CONCEPTUAL LAYOUT FOR: MOUNTAIN ROAD TRACT

PETITION NO: Z-11

Z-11 BROOKS CHADWICK CAPITAL, LLC

Re: Application of Brooks Chadwick Capital, LLC to Rezone a 38.975 Acre Tract
from R-30 to R-20 (No. Z-11)

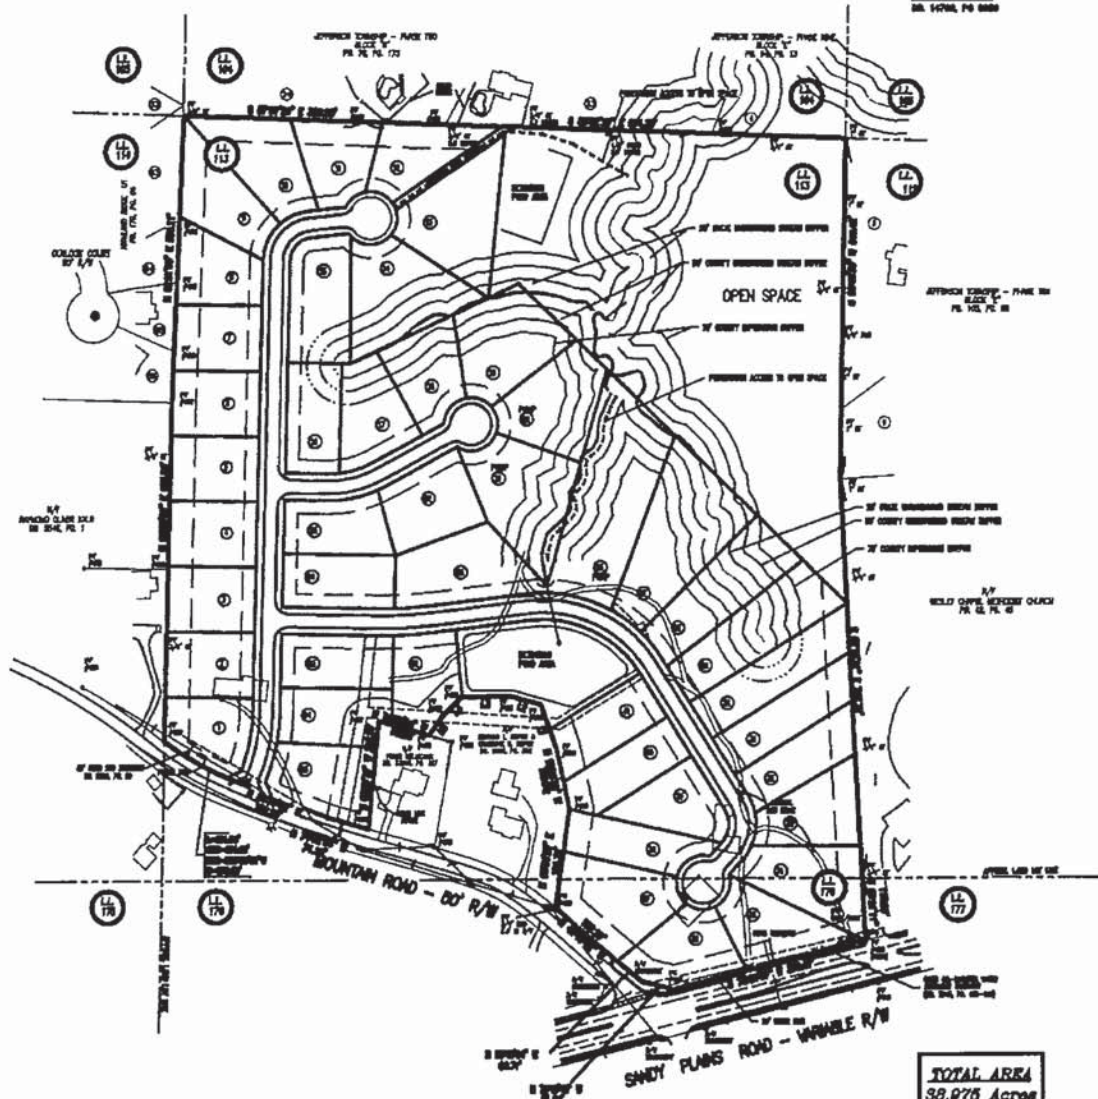
The applicant is also requesting a contemporaneous variance to waive the front setbacks from the required 35 feet to 25 feet. However, the site plan submitted indicates 45-foot rear setbacks on the exterior lots of the subdivision, 10 feet more than the required 35 feet.

- No Stormwater controls shown _____
- Copy of survey is not current - Additional comments may be forthcoming when current site conditions are exposed.
- No site improvements showing on exhibit.

1. This site is located on fairly steep terrain. Almost the entire site is located on slopes greater than 10% and approximately 29 percent of the site (outside the proposed open space area) is sloped at 25% or greater. A fairly large open space area has been reserved, however, and the proposed road layout does take advantage of the natural terrain and ridge lines. Several portions of the proposed site will require significant grading within the 25% steep slope area. These include the middle cul-de-sac, a significant portion of the northern detention pond and lots 14, 20, 21, 22 and 43. A revised site layout may help reduce these impacts. Elevated erosion control will be required to protect the receiving streams from impact due to this development. Drop foundations should be utilized where possible to minimize grading and land disturbance in the rear yards.

2. The Wesley Chapel Methodist Church located to the east has two detention ponds that discharge through this parcel. Adequate conveyance as well as twenty foot drainage easements must be provided through lots 29-33 to accommodate these discharge points.
